MEMO

To: Scott Simkus, Boulder County Housing Authority
From: Phillip Patterson, Director of Planning & Building
Date: October 9, 2006
Subject: Schematic Plan for 13-Acre Parcel in Lafayette

Excelsior Strike Camp Subdivision
Reception #2645429

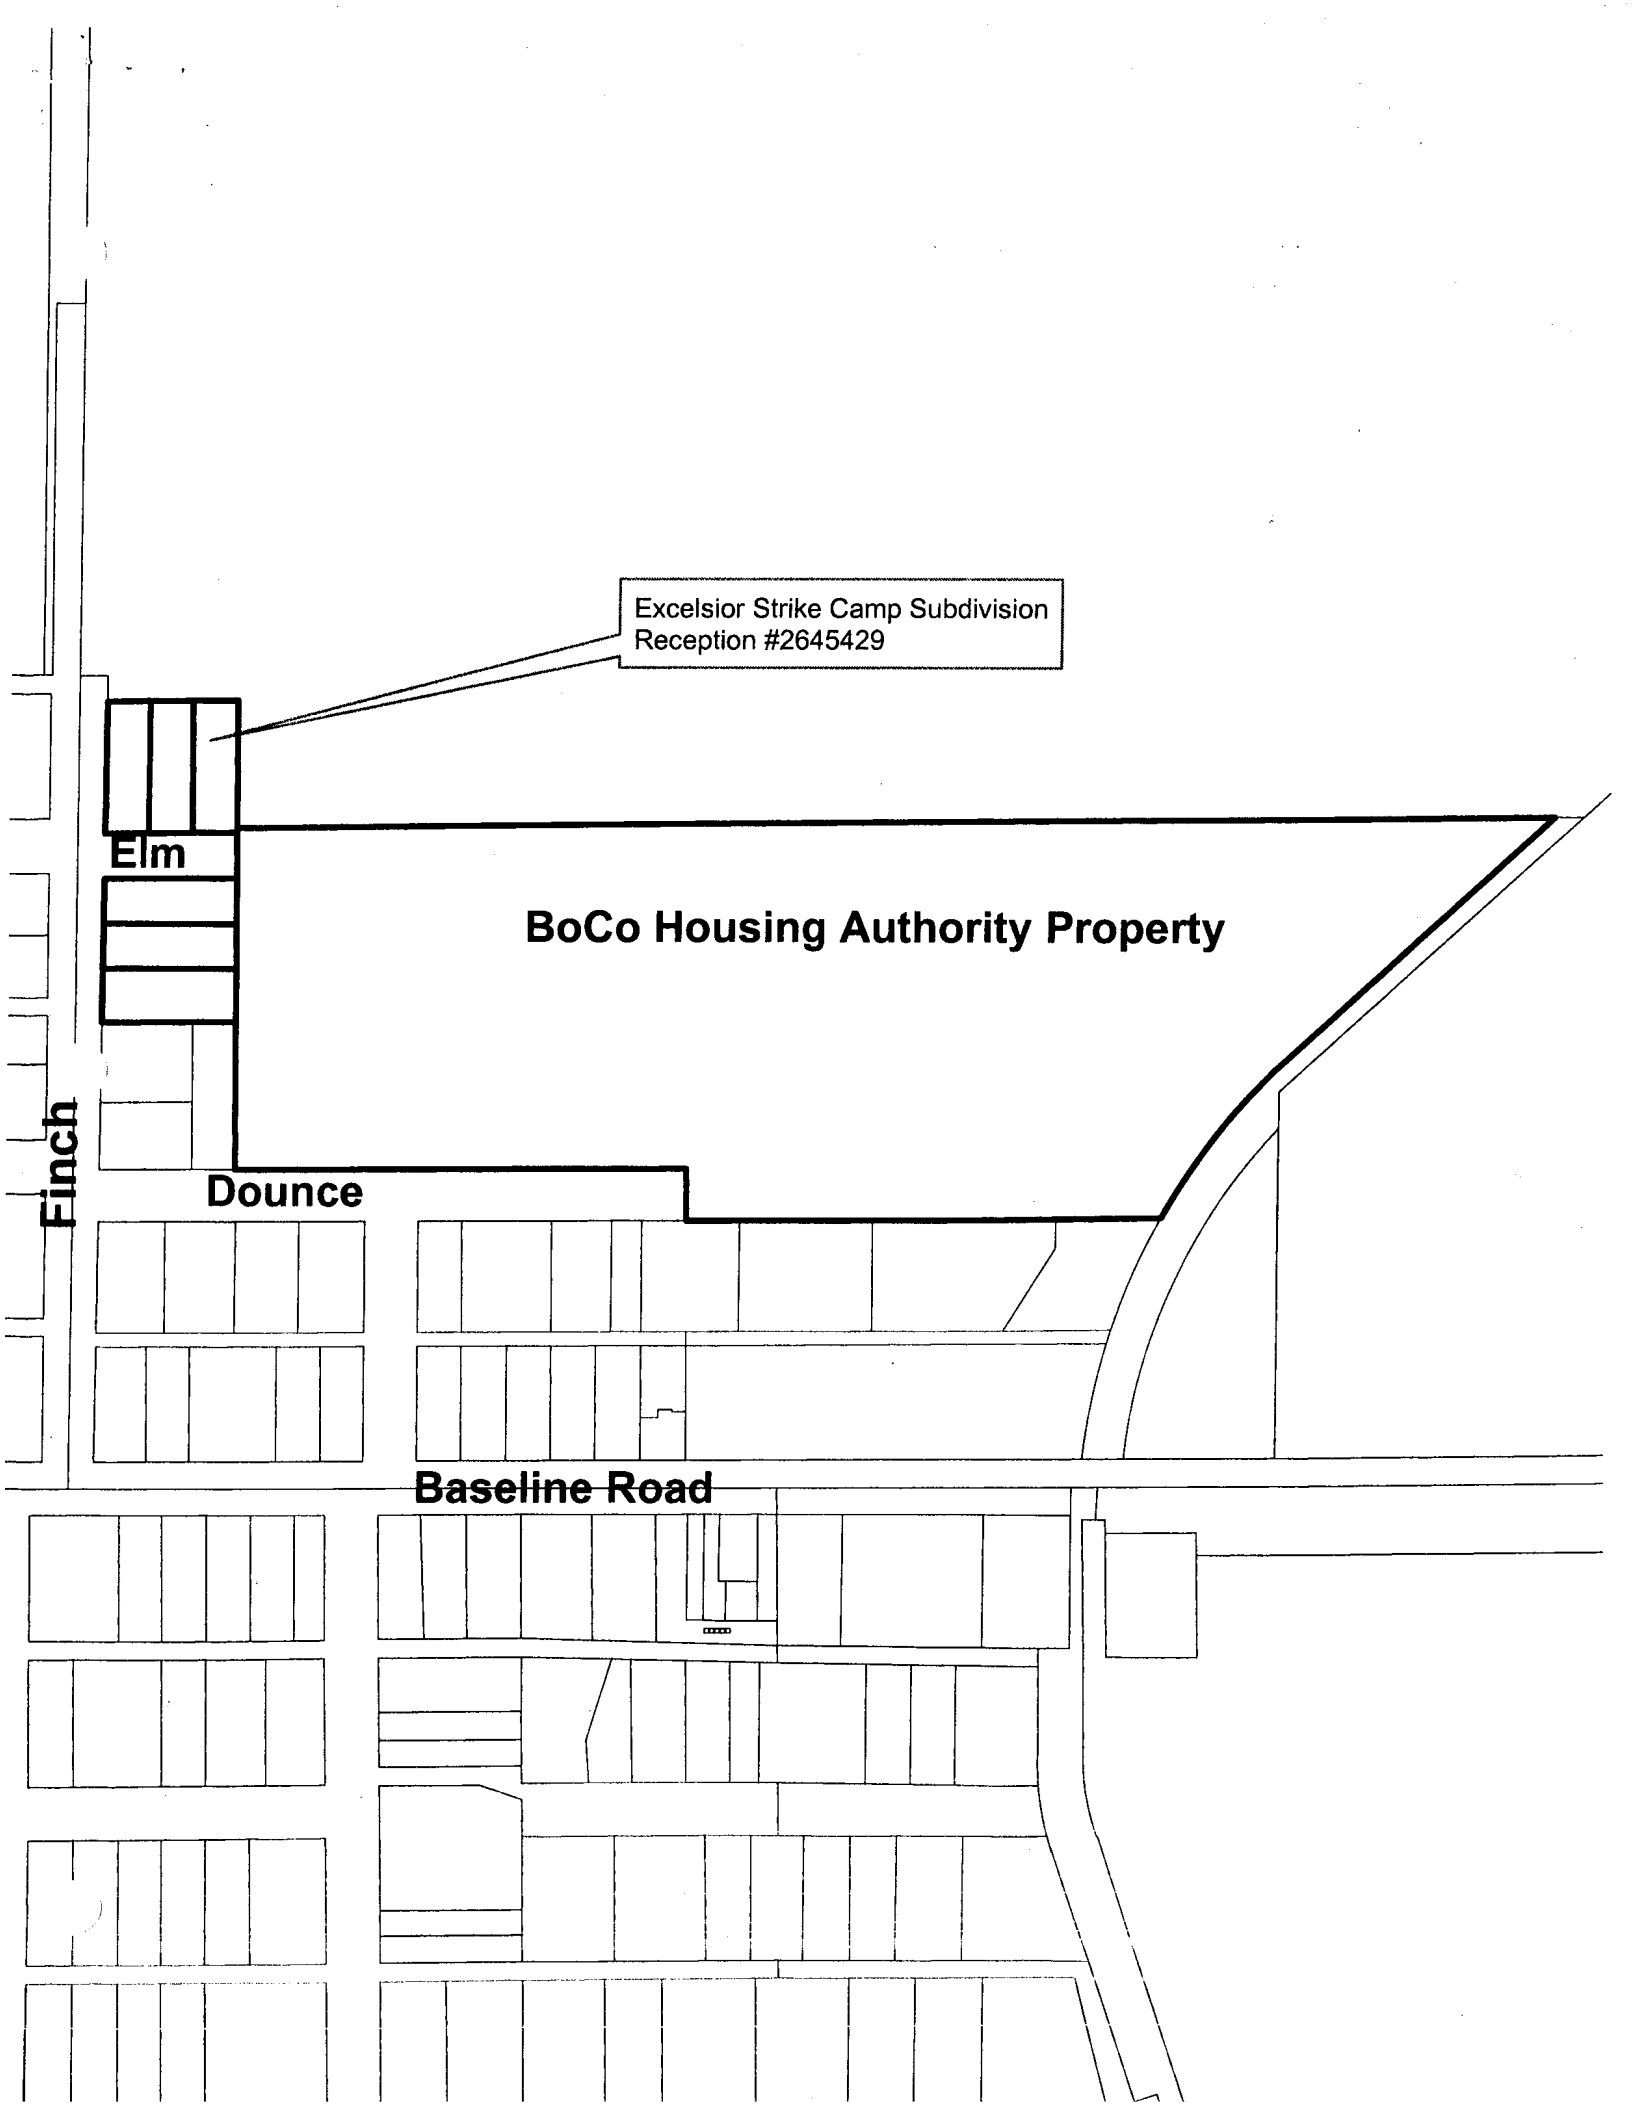
- The property abutting the subject property to the northwest has been replatted as the Excelsior Strike Camp Subdivision. This replat relocated the existing street right-of-way to the west to align with Elm Street. A copy of the parcel data indicating the location of the Elm Street realignment is attached. The schematic plan should have the proposed Ryan Street align with the replatted Elm Street, and Elm Street should be the road that is extended into the subject property from the west.

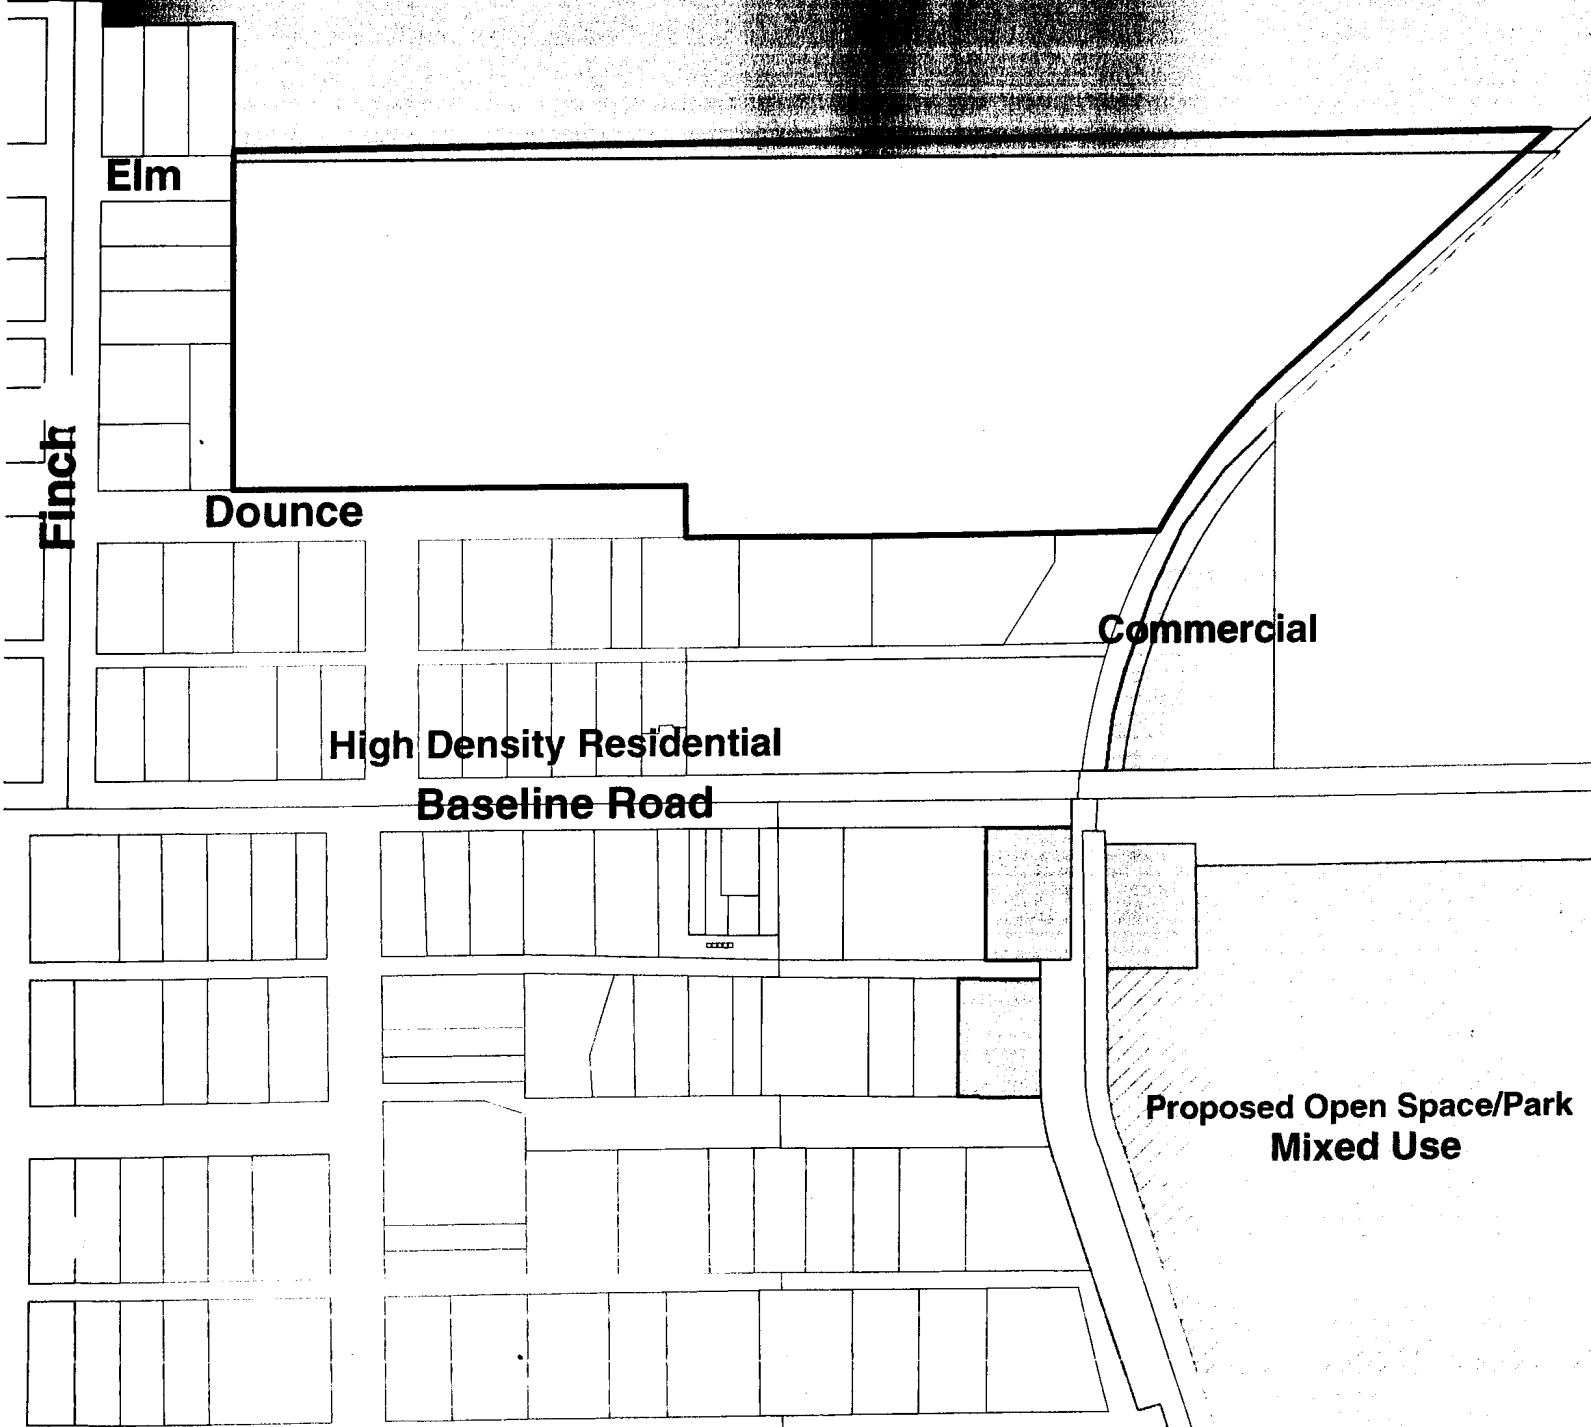
- The City's Comprehensive Land Use Plan's Land Use Map, copy attached, indicates High Density Residential land use for the subject property. The existing zoning for the property includes both R1 (Medium Density Residential) and DR (Developing Resource). As stated in your letter a rezoning request will need to be submitted. A rezoning to R3 (Multi-Family) may be appropriate with the required PUD overlay specifying the locations of the single-family, duplex, triplex, and townhome units.

- While duplexes are allowed in the abutting OTR and R2 zoning districts, we believe that the majority of the abutting residential structures are probably single-family detached. A plan that includes similar product along the southern edge and increases the density as one moves north might be more acceptable by the abutting property owners.
